RE: Response to Comments, Humboldt Mill Joint Permit Application for an Inland Lakes and Streams (ILSA) Permit, File Number 08-52-0104-P

KEMC Responses to U.S. Fish and Wildlife Service (USFWS) and U.S. Environmental Protection Agency (EPA) comments

RE: **Humboldt Mill Project Part 301 Inland Lakes and Streams Permit Application, MDEQ File No. 08-52-0104-P**

RE: Question 4 in USFWS May 27, 2009 Letter ILSA permit application

**Figure 1
UPPER BEDROCK
POTENTIOMETRIC
SURFACE MAP
HUMBOLDT HTDF**

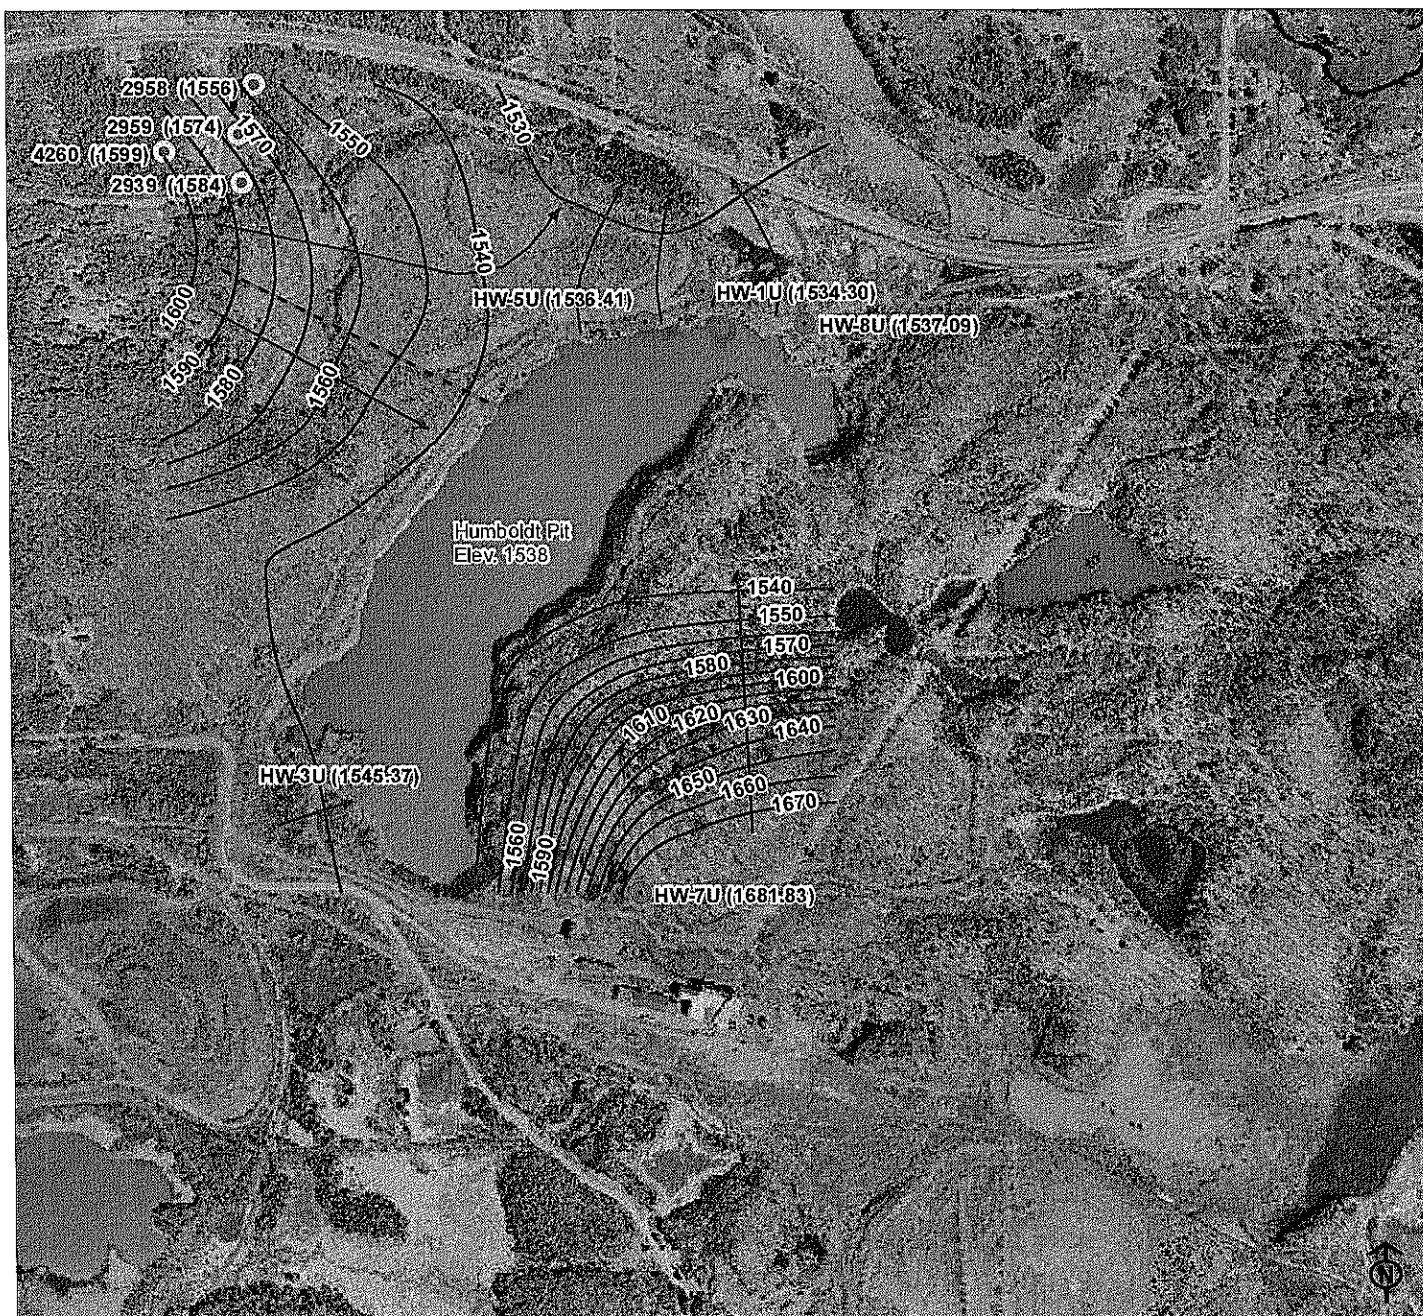
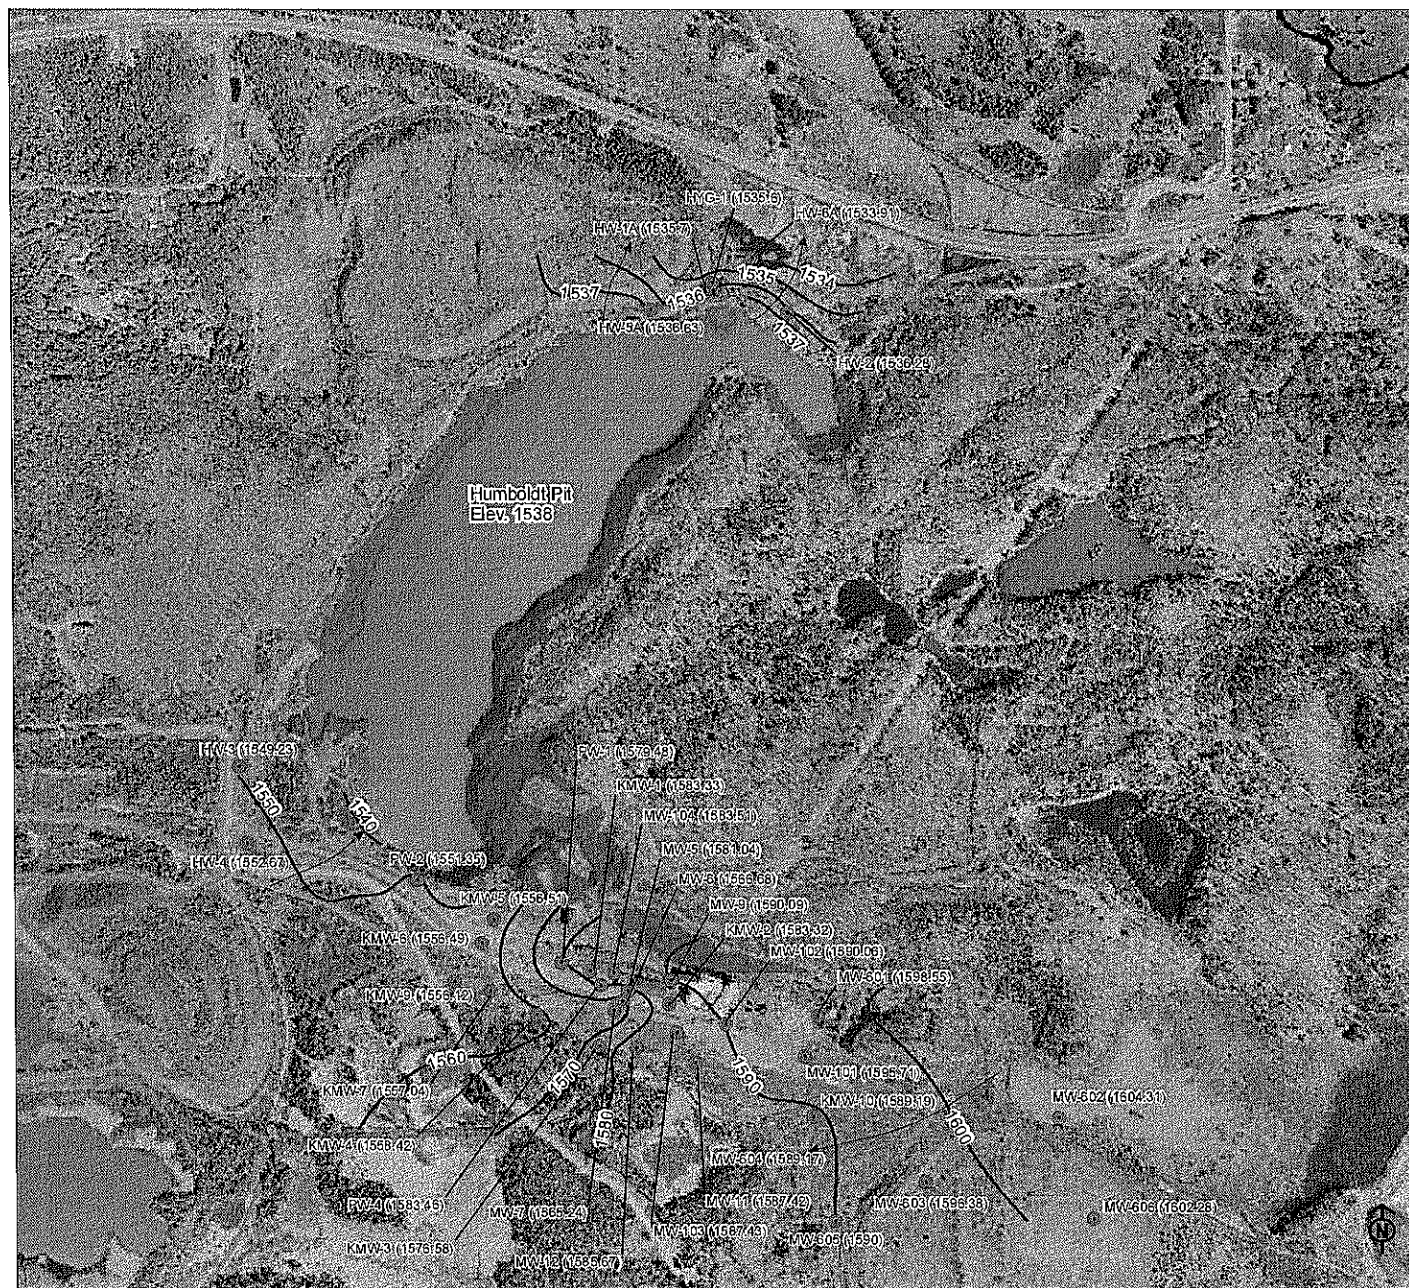
Page 2, Item 2. *The applicant indicates the HTDF does receive some inflow from groundwater. A. Will adding 75 feet of mine tailings to the HTDF alter the groundwater flow into the HTDF? If the groundwater inflow is decreased, is precipitation enough to maintain the surface elevation at 1,538 feet?*

The approximate direction of the groundwater flow gradients for upper bedrock groundwater flow and alluvial, unconsolidated aquifer flow are indicated by flow arrows shown on Figures 1 and 2, respectively. A hydrogeological cross section with groundwater potentiometric contours is presented in Figure 3. In both bedrock and unconsolidated systems, the direction of the gradient is towards the HTDF from the south, east and west, and away from the HTDF at the north end. The proposed operation of the HTDF and the addition of tailings will not change the direction of groundwater seepage into the HTDF.

Figure 4
NORTHERN
ALLUVIAL AQUIFER
POTENTIOMETRIC MAP
HUMBOLDT HTDF

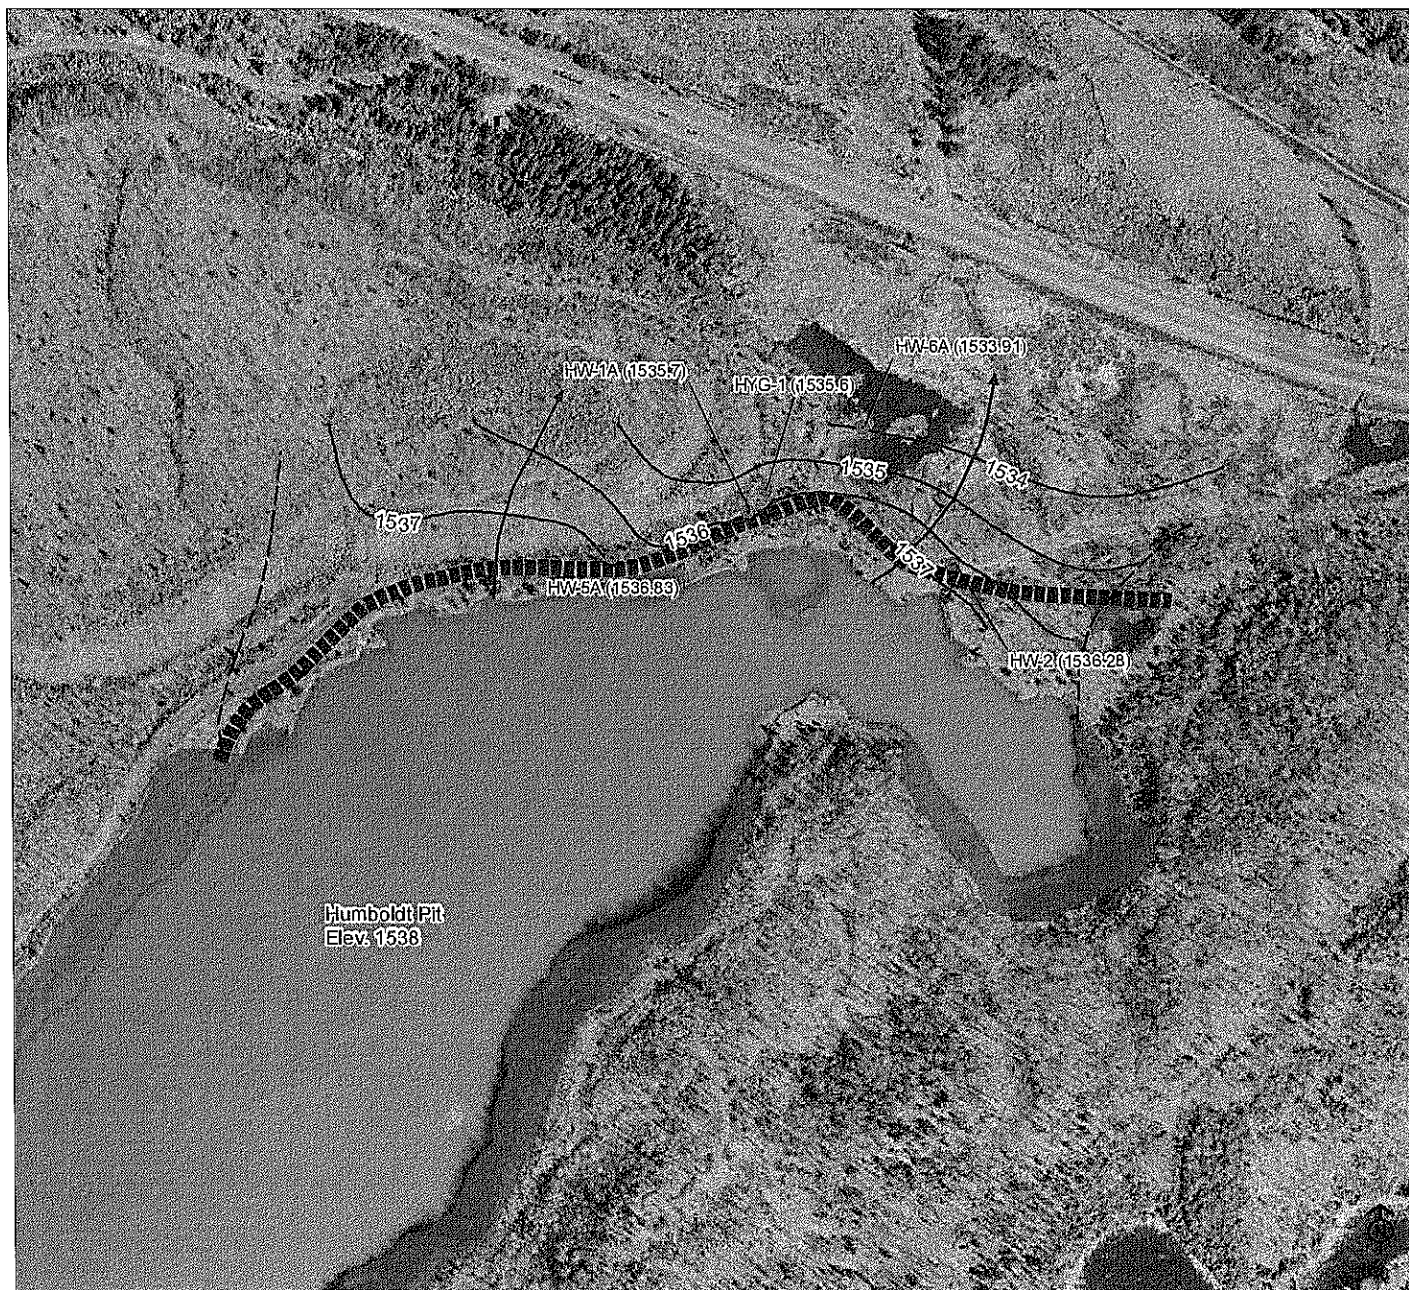
Page 3, Item 3. *The applicant proposes to construct a slurry wall and berm to prevent groundwater and surface water from leaving the HTDF. We have concerns that groundwater could leave the site and gain access to surface waters. Is there fractured bedrock that would allow groundwater seepage at other locations that the proposed slurry wall? We recommend the applicant clarify the potential for groundwater seepage from the HTDF.*

The proposed location of the containment wall is shown relative to existing alluvial, unconsolidated aquifer potentiometric surface contours in Figure 4. Based on the HTDF water balance (Hydrologic and Geochemical Mass balance Model Report, Humboldt Mill Part 632 Permit Application, Volume IA, Appendix D) and the current design considerations for the cutoff wall with a thickness of four feet, an average hydraulic conductivity in the range of 10^{-7} cm/s, and a wall area of 97,000 square feet (Attachment B11, May 2009 Response to MDEQ Comments, Humboldt Mill Part 632), flow through the cut-off wall has been estimated at approximately 0.6 gpm on an annual basis (estimate from Foth I&E analytical calculations). Compared to the current flow through the unconsolidated materials at the north end of the HTDF estimated with the same analytical method under existing conditions (246 gpm), the proposed cutoff wall will decrease mixing of untreated HTDF water with alluvial groundwater by a factor of approximately 400 and thus will be 99.7% effective in preventing HTDF groundwater mixing relative to current conditions (Foth I&E analytical calculations). This operational condition is anticipated to improve existing groundwater quality in the alluvial aquifer north of the HTDF.
